ENGINE - HP TURBINE ROTOR AND STATOR ASSEMBLY - PROVIDE A NEW STAGE 1 HPT BLADE -
CATEGORY CODE 7 - MOD.ENG-72-0146

V2500–ENG–72–0146

Location of the Stage 1 HPT Blade
Fig.1

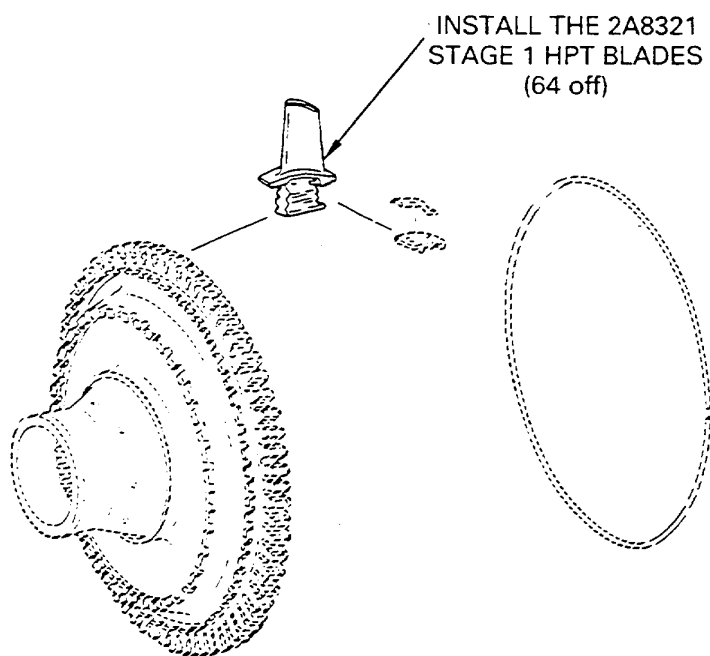
To provide a new Stage 1 HPT Blade with revised crossover slots in the leading edge impingement rib of the casting and a shorter trailing edge platform.

- (1) Provide a new Stage 1 HPT Blade with revised crossover slots in the leading edge impingement rib of the casting and a shorter trailing edge platform.

- (1) Install the 2A8321 Stage 1 HPT Blades (64 off) by the approved procedure given in Reference (2), Chapter/Section 72-45-10, Assembly, and Figure 1.

- (2) Install the 2A8321 Stage 1 HPT Blades (64 off) by the approved procedure given in Reference (3), Chapter/Section 72-45-10, Assembly, and Figure 1.
